Perry Nuclear Power Plant
Docket Nos. 50-440; 50-441
Response to Request for
Additional Information -
Management Organization

This letter transmits our responses to a January 6 letter in which 18 questions were posed by the NRC Licensee Qualification Branch on the Perry Nuclear Power Plant Site and CEI Corporate organization.

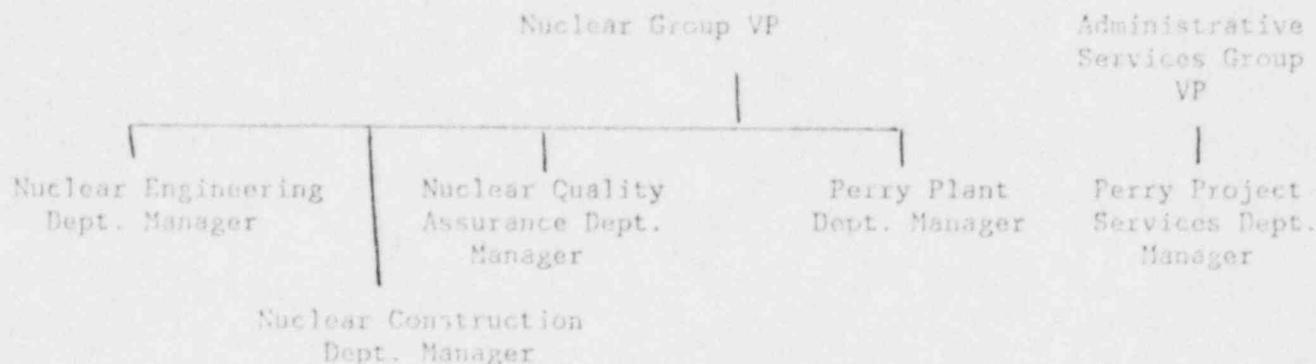
Explain plan for staffing support positions at the time of post start-up of Unit 1 when resources will be split between operational support on Unit 1 and start-up support for Unit 2.

The Perry Nuclear Power Plant Site Organization will reorganize prior to fuel load for Perry 1 to separate the support functions for Perry 1 start-up and operation from the support functions for construction of Perry 2. Six months prior to fuel load for Perry 1, the site organization will be as follows:

Engineering support for Perry 1 will be provided by the Nuclear Engineering Department; engineering support for Perry 2 construction will be provided by the Nuclear Construction Department. Similarly, Nuclear Quality Assurance Department staff will be divided into two sections: the Construction Quality section will support Perry 2 construction and the Operational Quality section will support Perry 1 start-up and operation.
